**U.S. Army Corps
of Engineers**
Honolulu District

Public Notice No.
POH-2005-399

**PROPOSED MODIFICATION OF DEPARTMENT OF THE ARMY PERMIT
FOR SHORELINE PROTECTION AND CULVERT RECONSTRUCTION AS PART OF
THE AOA VILLAGE ROAD RECONSTRUCTION PROJECT AT AOA BAY,
TUTUILA, AMERICAN SAMOA**

Figure 3. Plan view of project with proposed modifications

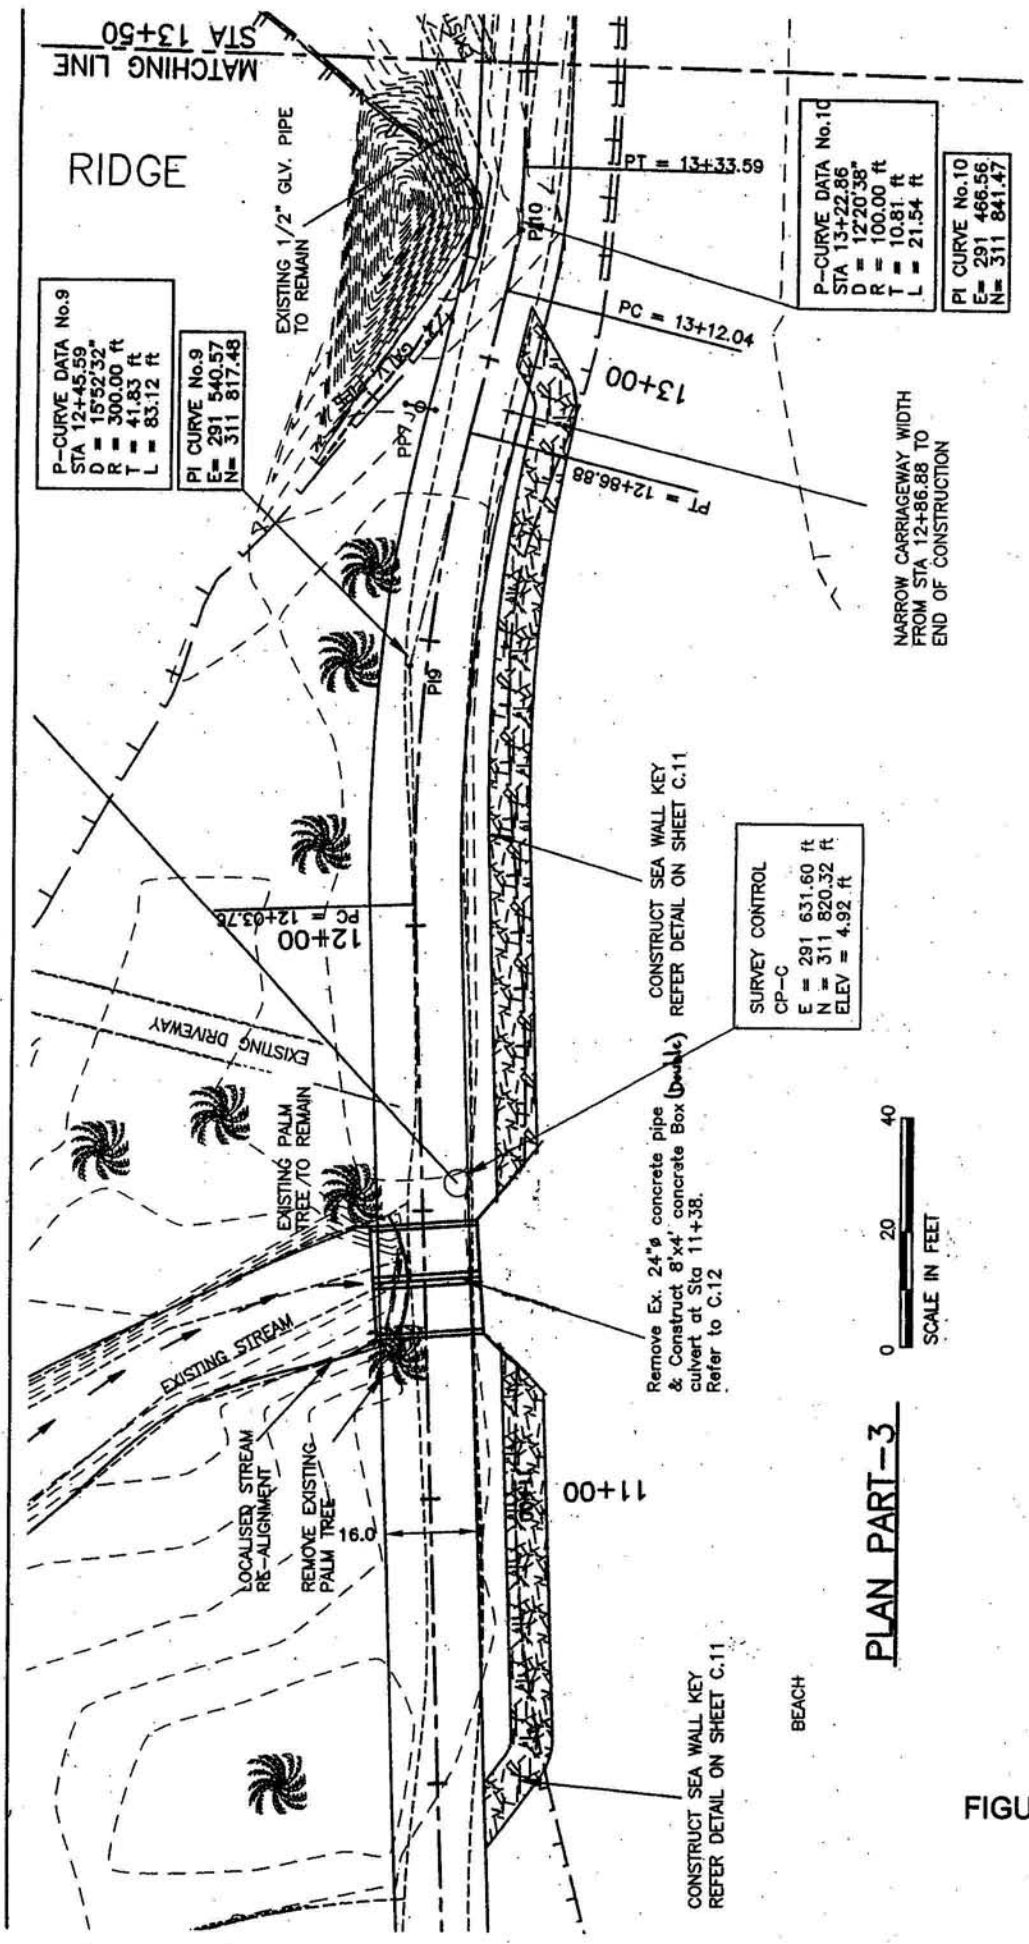
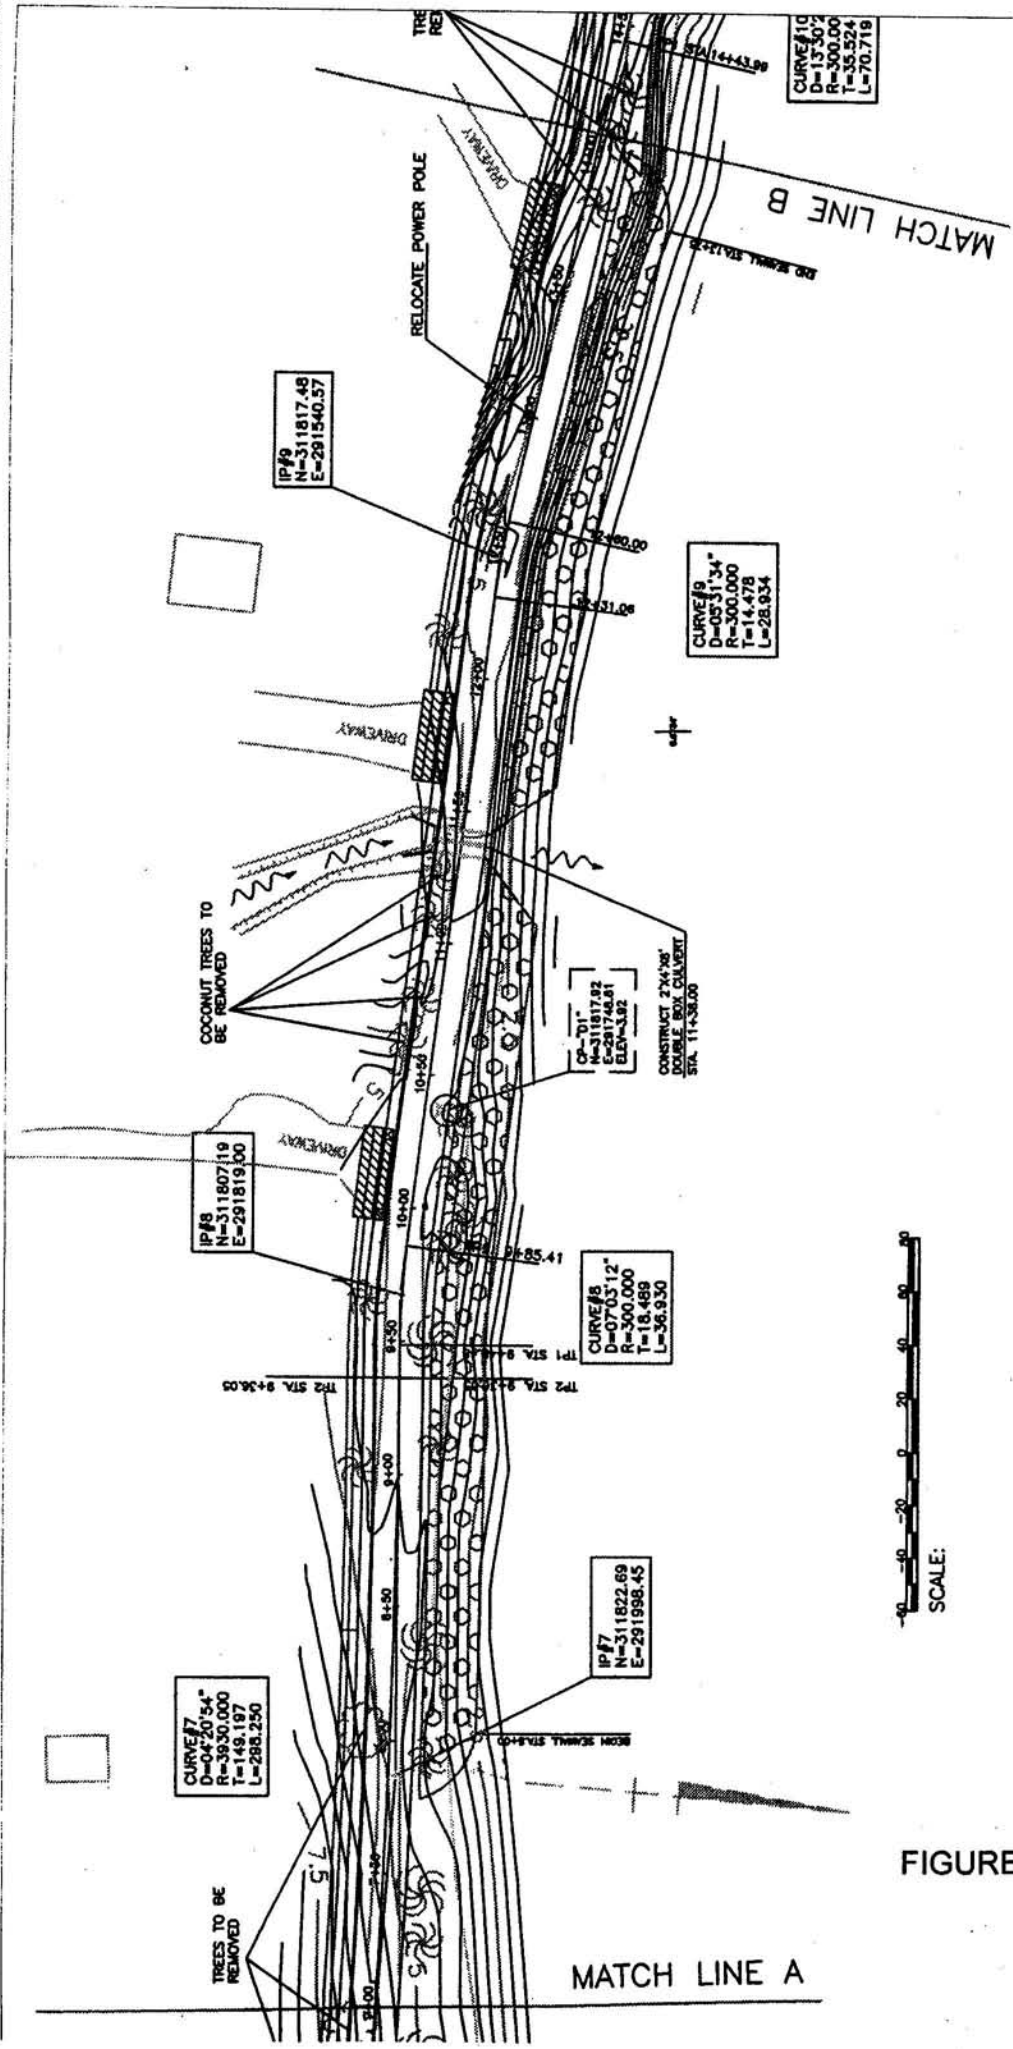
Due to extensive damage to the village road which resulted from tropical cyclone Heta in January 2004, the DPW has determined that a substantial increase in the length of the planned shoreline revetment is necessary and has requested modification of the issued DA permit to authorize the proposed project changes (Figure 3). Work at the stream crossing would remain unchanged. The revised project description follows, with the revised values in **bold** and the original values in brackets [].

The planned shoreline revetment would be approximately **600** [260] feet in length (approximately Stations **8+00 to 14+00** [10+40 to 13+00]), consisting of two segments separated by the outlet of Vaitolu Stream. Revetment construction would follow the design shown in the typical sections (Figures 4, 5). Construction would involve excavation of approximately **510** [220] cubic yards (CY) of material from an area of approximately **350** [150] square yards lying seaward of the MHW line. Revetment construction would also involve the discharge of fill material consisting of 1000-1700 pound armor rock (**930** [400] CY), 100-200 pound underlayer stones (**1100** [475] CY), compacted fill (**650** [280] CY), and geotextile (**2350** [1000] square yards (SY)). The compacted fill would consist of selected excavated material and granular fill from a quarry. The source of armor and underlayer stones has not been specified.

The total area of excavation in waters of the U.S. for the project would be approximately **350** [150] SY (**0.07** [0.03] acre). The total area of fill to be discharged into waters of the U.S would be approximately **725** [278] SY (**0.15** [0.06] acre).

FIGURE 6

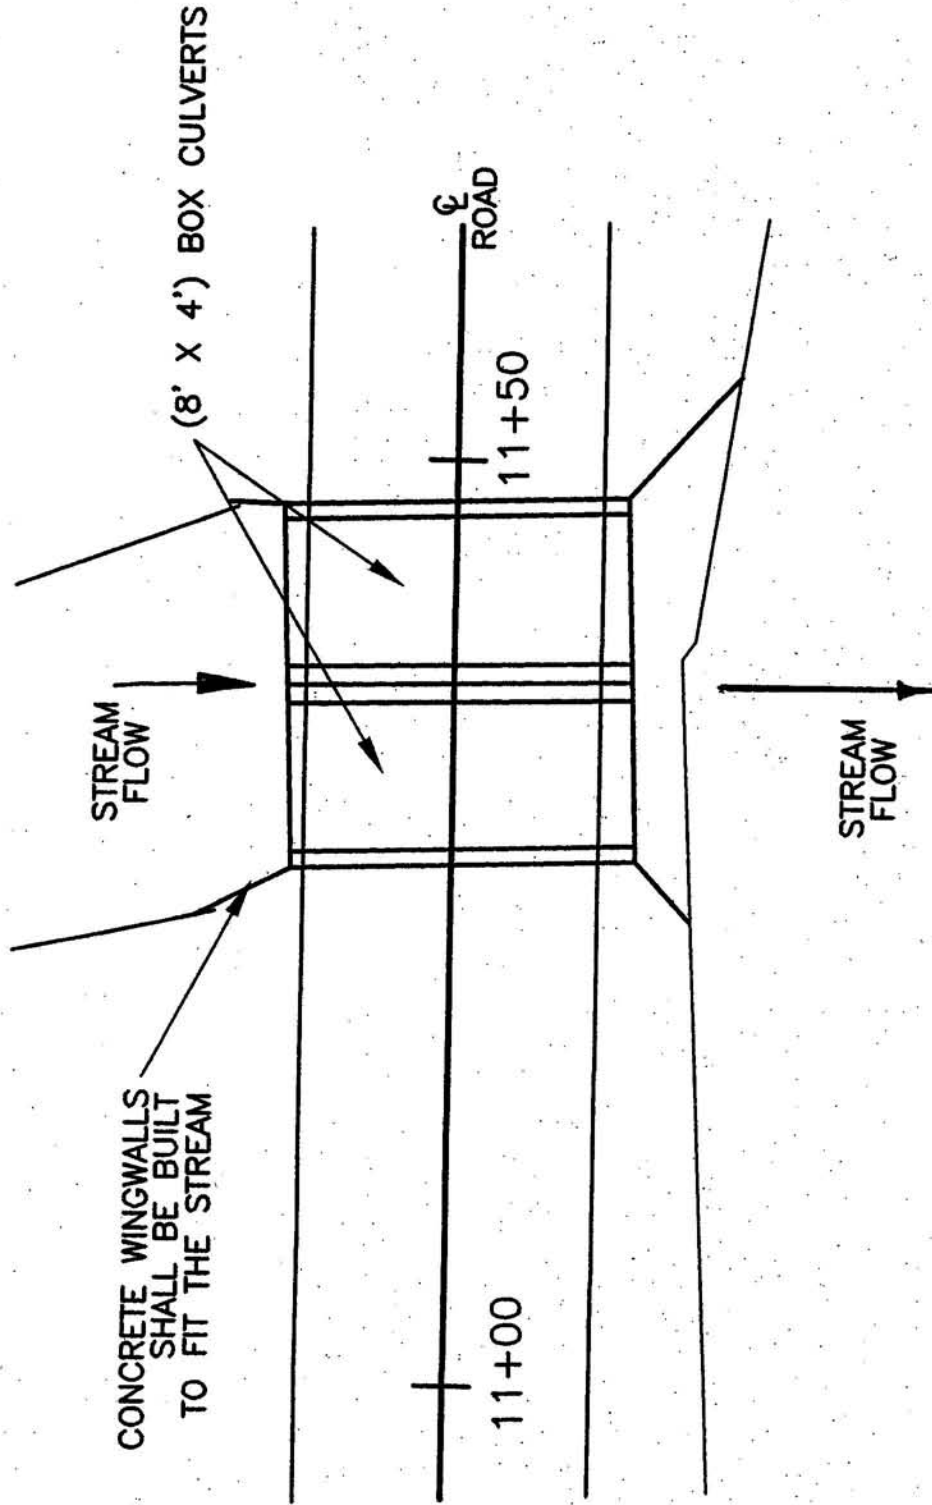
At the stream crossing, the applicant plans to replace the existing 24 inch concrete pipe culvert with an 8 x 4 foot concrete double box culvert and wing walls (Figure 6). The upstream wing walls would be approximately 10 feet in length and the downstream wing walls would extend to the new revetment. The culvert replacement would involve excavation of the existing culvert and the discharge of approximately 95 CY of material, consisting of concrete and backfill, and approximately 435 SY of geotextile.
